PROJECT REFERENCE NO.	SHEET NO.
U-4405	UC-48
DESIGNED BY: AMH	8/8/2018
DRAWN BY: AMH/AB	
CHECKED BY: AMH	
APPROVED BY: MWF	
REVISED:	
NORTH CAROLINA DEPARTMENT OF TRANSPORTATION	
UTILITIES ENGINEERING SEC. PHONE:(919)707-6690 FAX:(919)250-4151	UTILITY CONSTRUCTION PLANS ONLY

UTILITY CONSTRUCTION

Fayetteville Public Works Commission

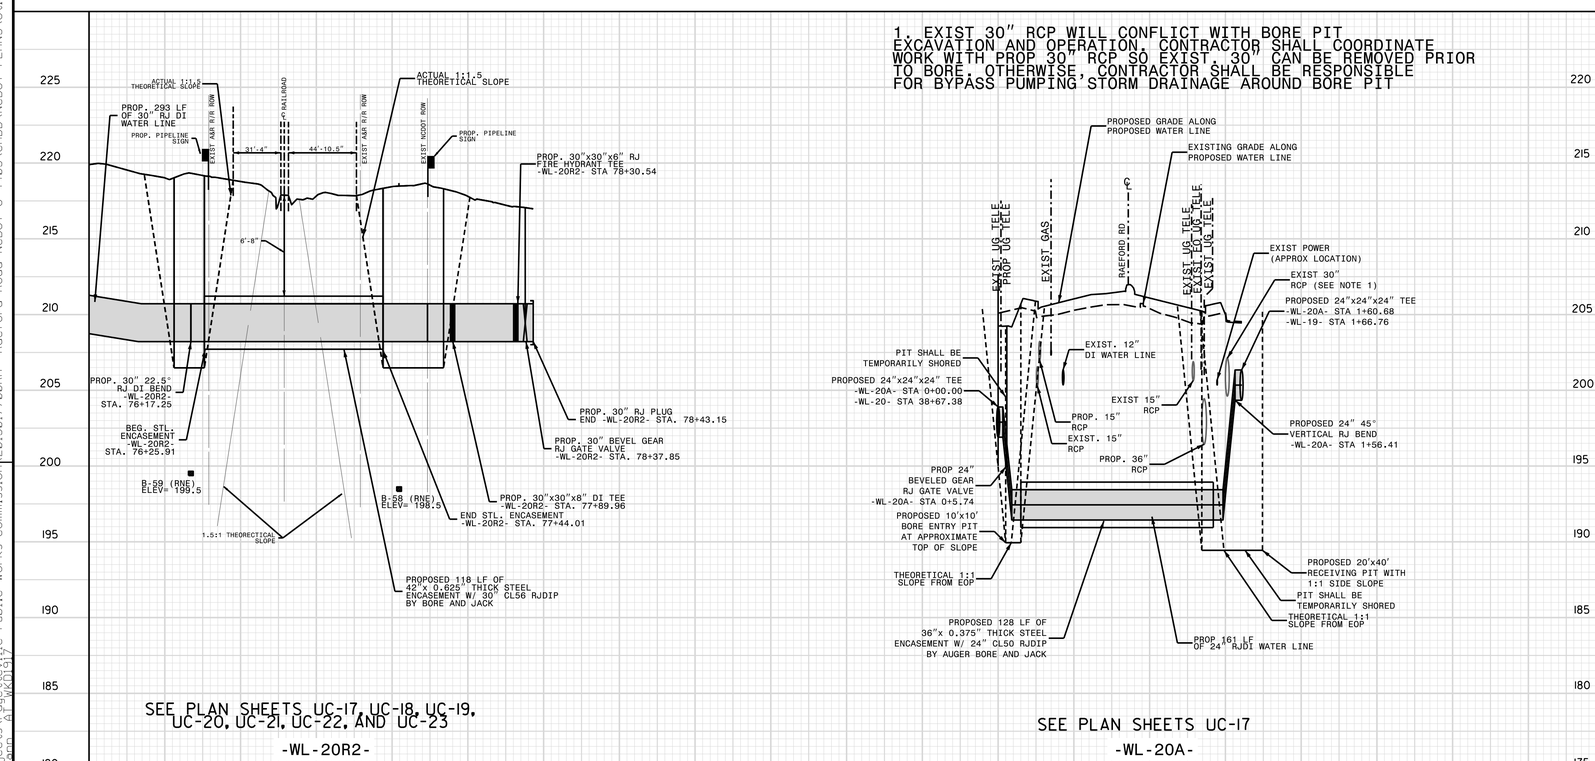
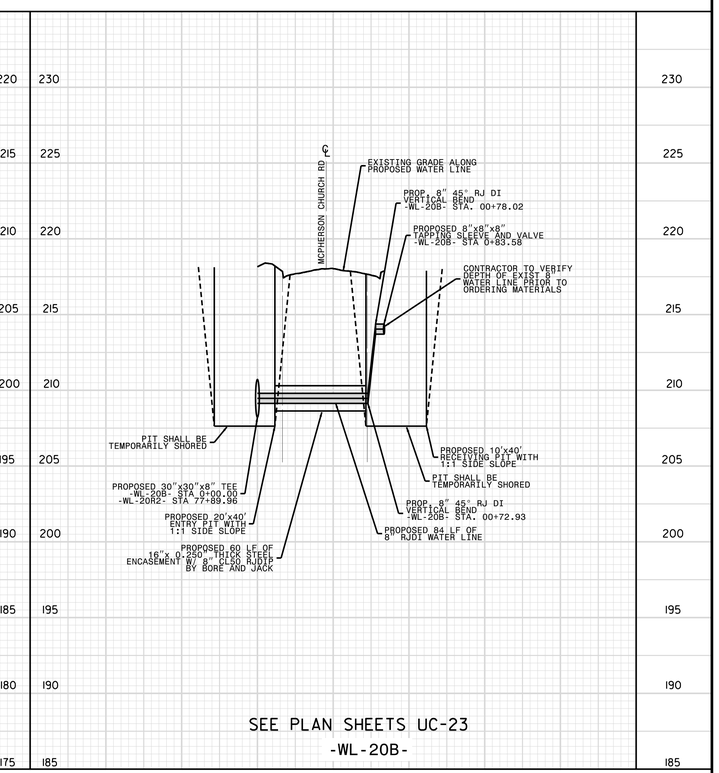
UTILITY REV - JULY 23,2018 - SHEETED PROP VALVE TO -WL-20R2- STA 78+37.85
- ADDED LABELS FOR PROP. 30"x30"x12"x12" AT WL-20R2 STA 68+20
- ADDED LABELS FOR PROP. 30"x30" AT WL-20R2 STA 68+20
- REVISED LENGTH CALLOUT FOR 42" ENCASEMENT
